Change Notice

YB & YB2 Series

Change of Knurled Mounting Nut

Change of Knurled Mounting Nut	
Before Change	After Change
 <p>Material: PBT</p>	 <p>Material: Fiber Reinforced PBT</p>

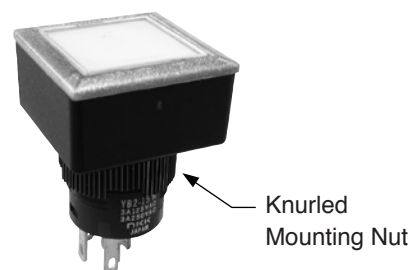
The height and material of the knurled mounting nut will change.

- No change in panel thickness, cutout, or mounting torque.
- AT106 socket wrench can still be used.
- Contact factory for further details.
